CHILDREN'S HOSPITAL
OF ORANGE COUNTY

TOWER II

LEVEL 2 MECHANICAL PLAN
AREA - J

M3.2J

LEVEL 2 MECHANICAL PLAN AREA - J

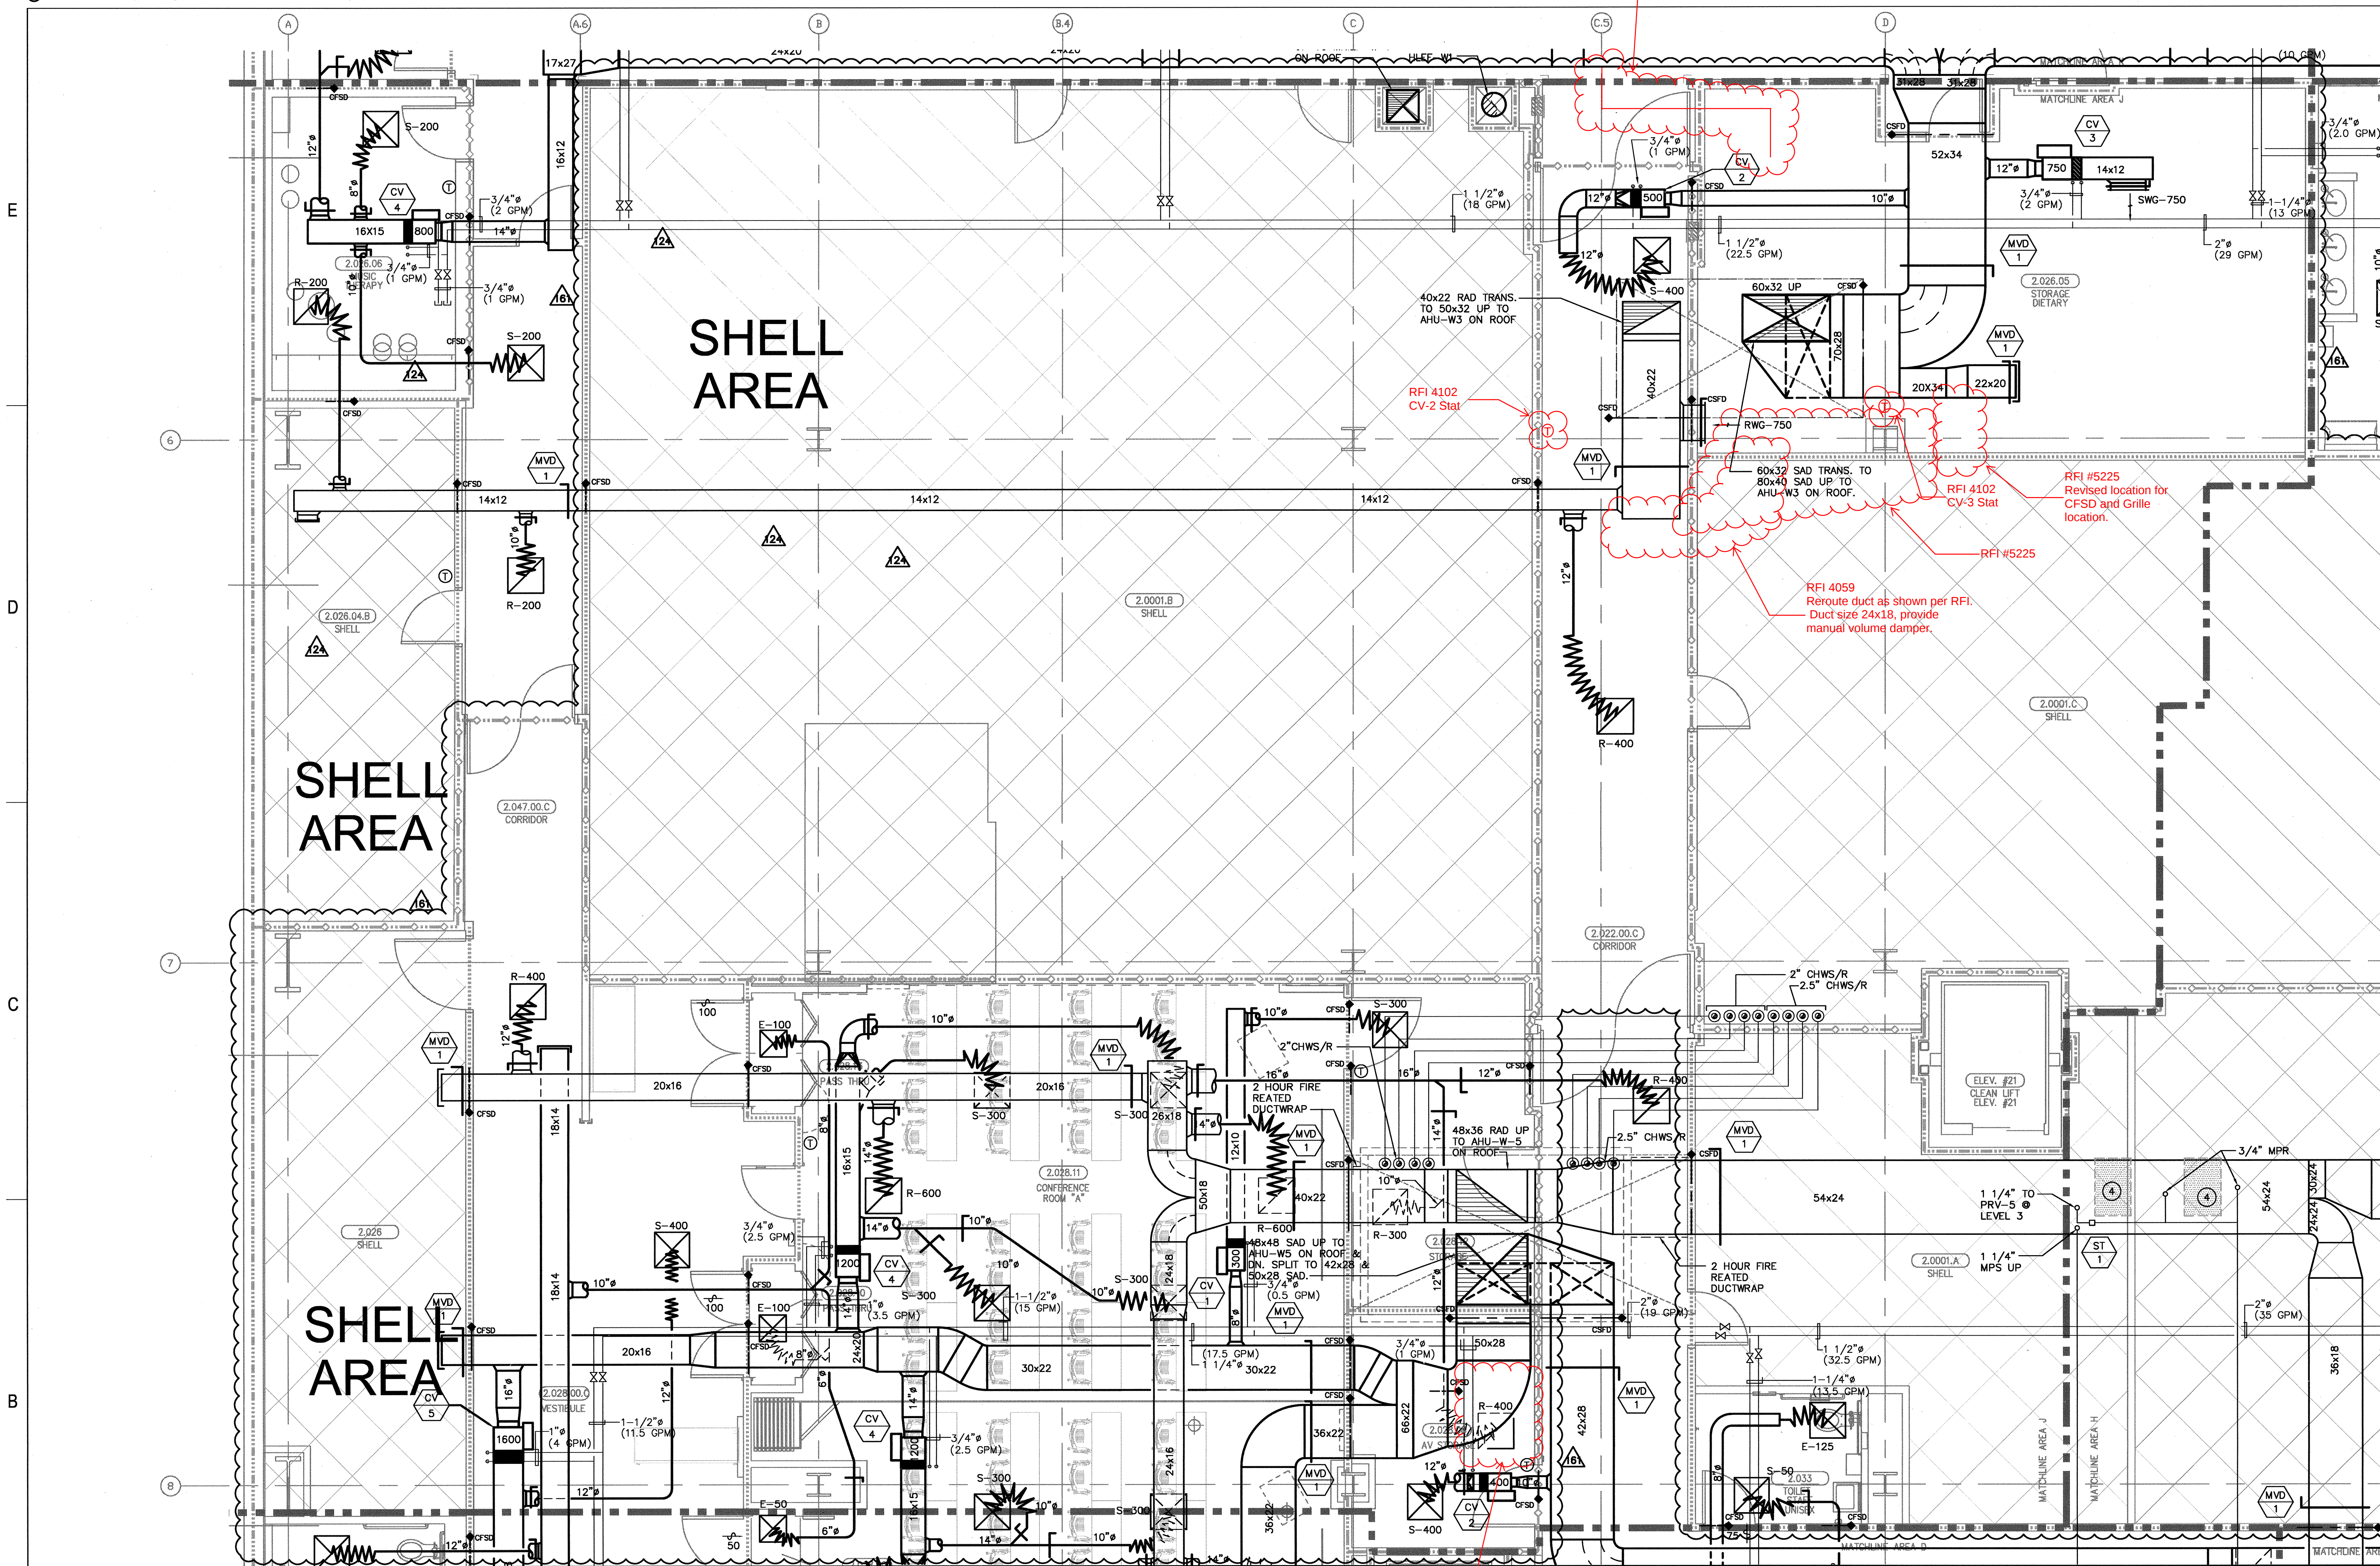
RFI #4450
Relocate return grille
and reroute duct
feeding room 2.028.08.
